**Turtle Creek No. 3 Primary Pump Station Project**  
**Solicitation Number: CO-00404-SM**  
**Job No.: 21-6001**

**ADDENDUM NO. 5**  
**September 22, 2021**

**PUMP STATION MECHANICAL PIPING PLAN**

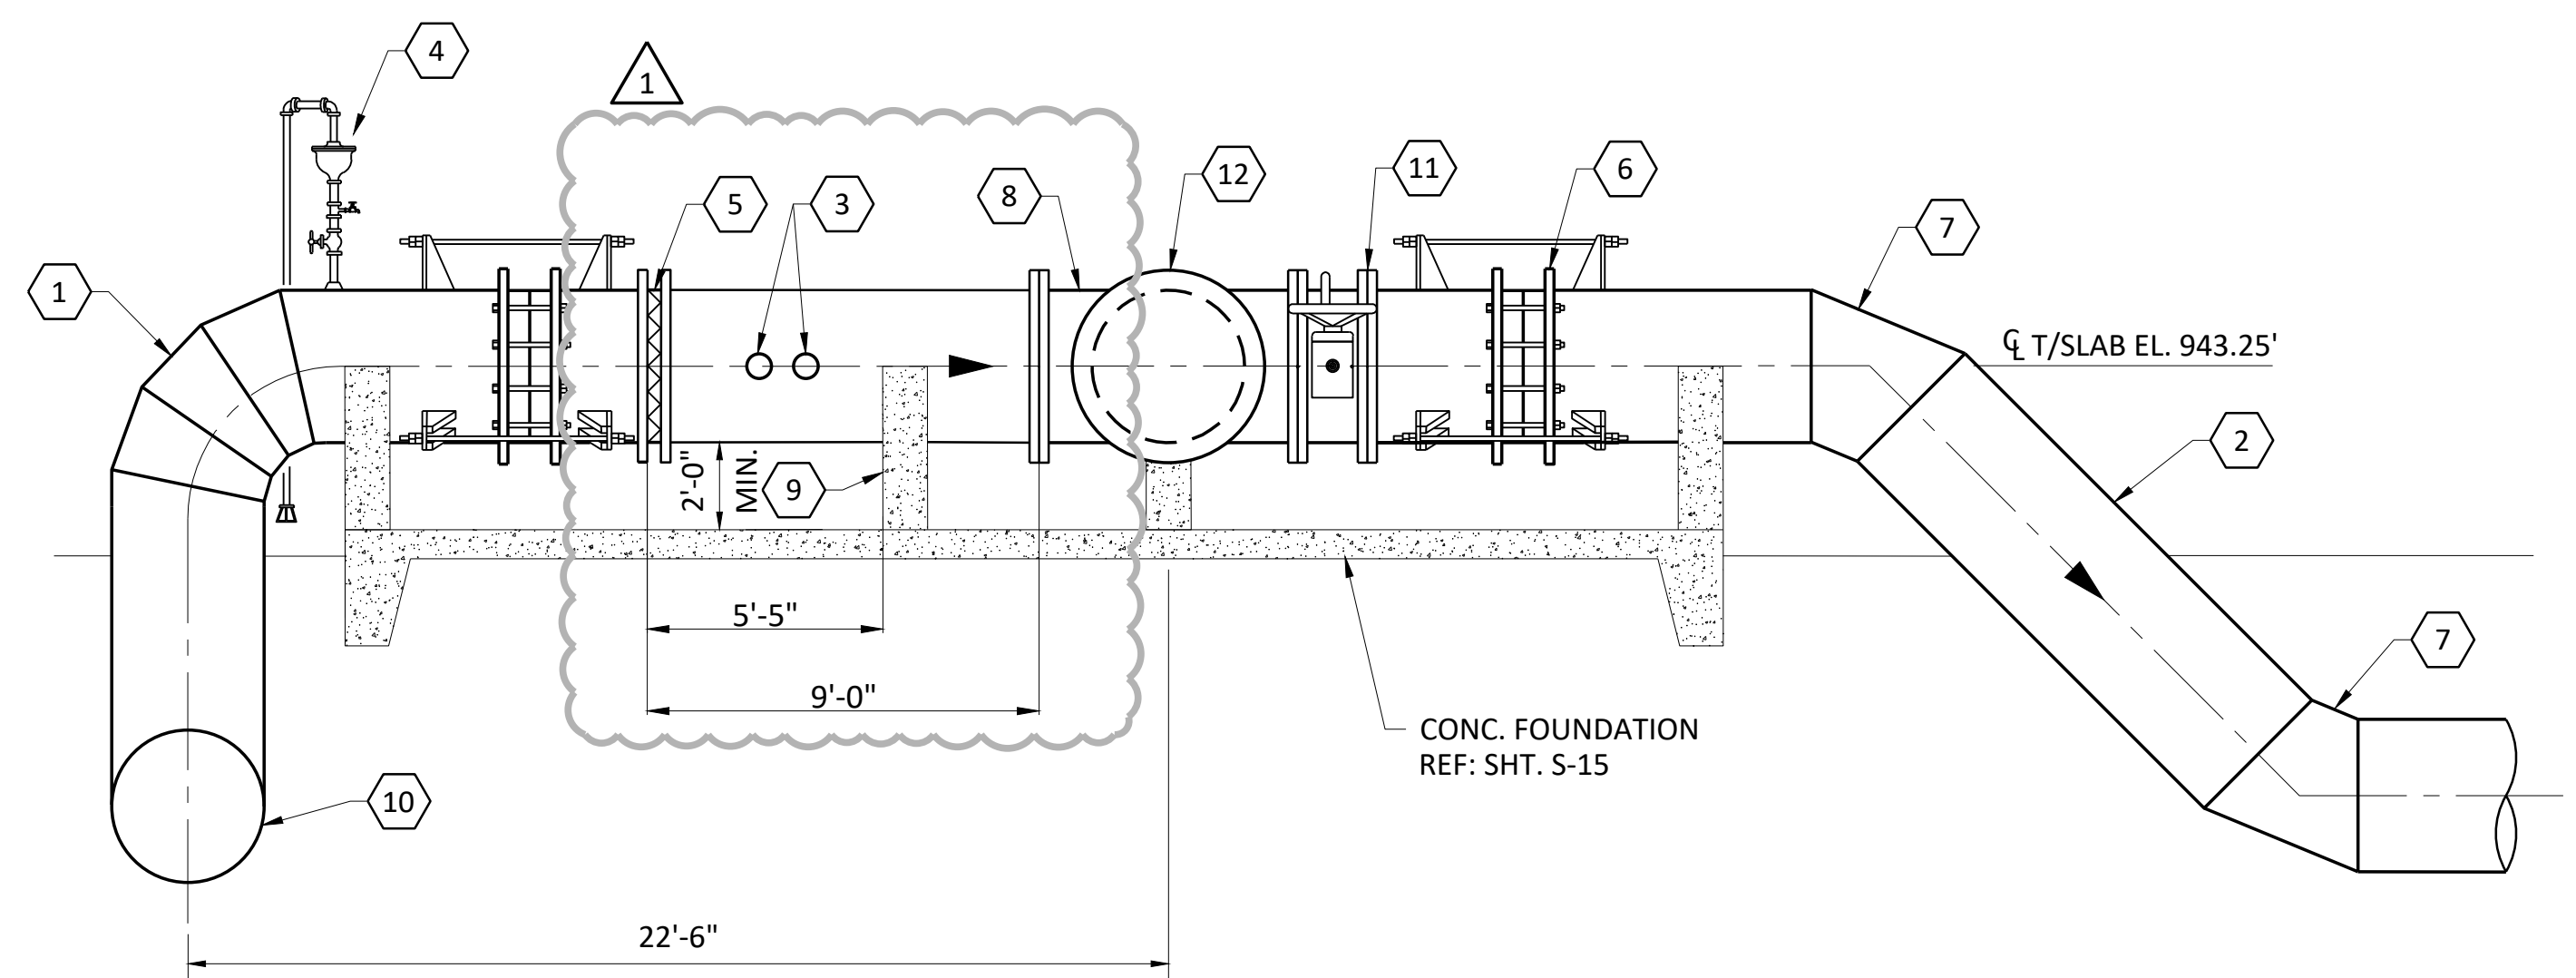
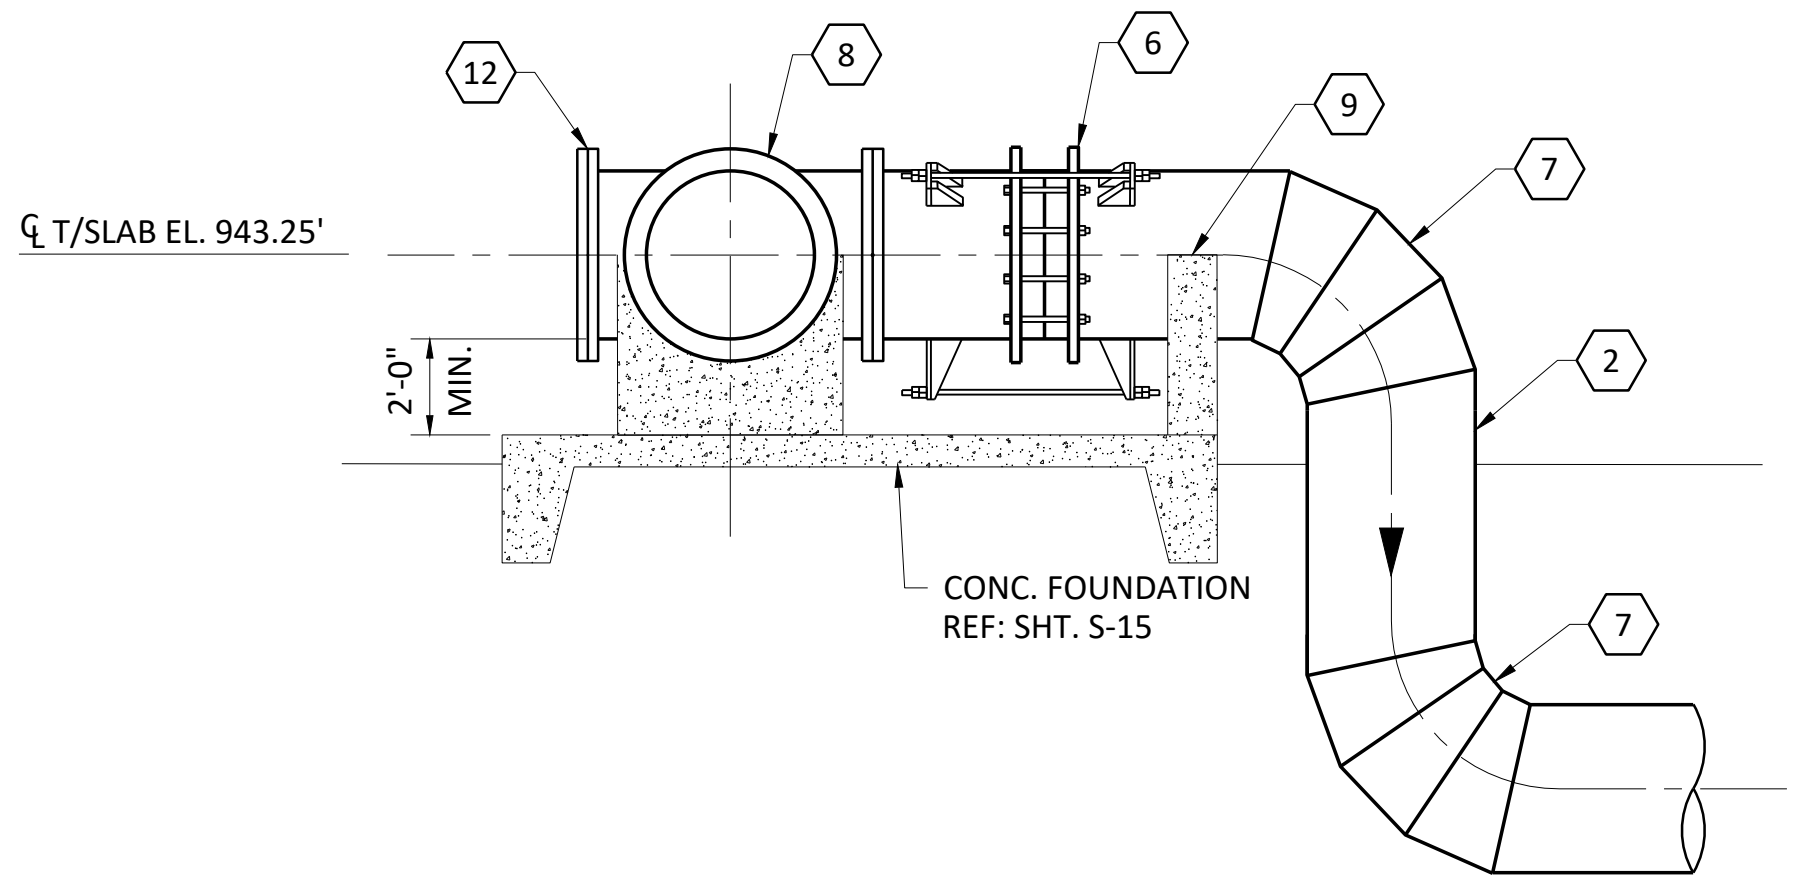
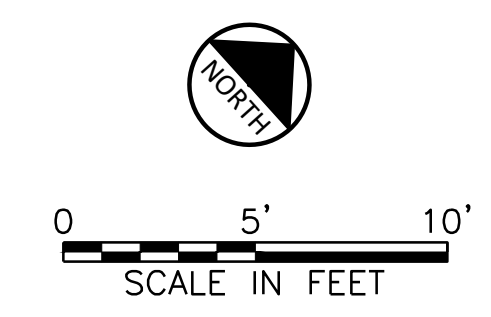
- 27. Question: DWG'S PS1 WORK NOTE 18 AND DWG PS2 WORK NOTE 21 CALL FOR RESTRAINED FLEXIBLE COUPLINGS. THE ONLY FLEXIBLE COUPLING SPECIFIED IS IN SECTION 33 11 13.13.2.02.L AND IS NOT A RESTRAINED COUPLING. FURTHER, THE RESTRAINED COUPLINGS ON DWG'S PS1 & 2 APPEAR TO BE SHOWN AS DEPEND-O-LOK TYPE. WHAT TYPE OF COUPLING IS REQUIRED AT THIS LOCATION?**

*Response: Note by Symbol 18 on Drawing PS-1 and Note by Symbol 21 on Drawing PS-2 have been modified to specify a flanged coupling adapter which must conform to Section 33 11 13.13 Steel Pipe (AWWA C200). Refer to Item No. 4 and 5 in the CHANGES TO THE PLANS section of this addendum.*

3. **Delete** Drawing P-16 in its entirety **and replace with** revised Drawing P-16 included in this addendum.
4. **Delete** Drawing PS-1 in its entirety **and replace with** revised Drawing PS-1 included in this addendum.
